### MINISTRY OF SUPPLY - D.L.R.D.(A)/R.A.E.

# CV2165

SPECIFICATION CV. 2165

AMENDMENT No. 1.

Page 3 Outline Drawing

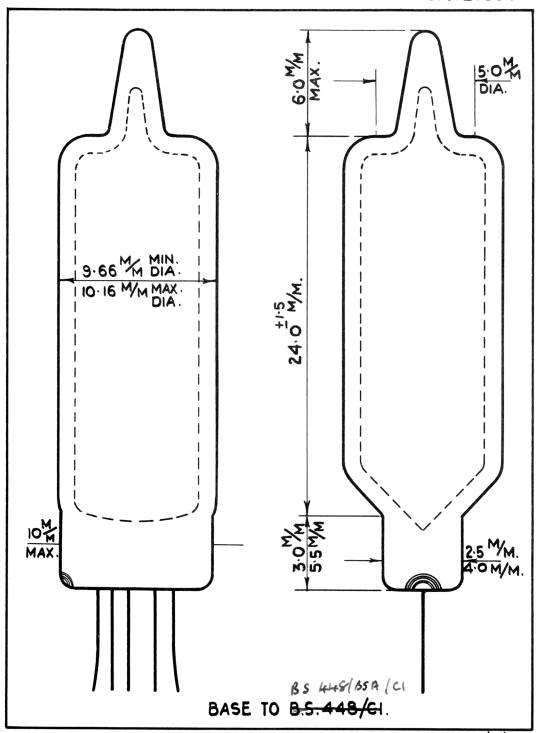
Amend "Base to BS.448/C1" to read "BS.448/B5A/C1".
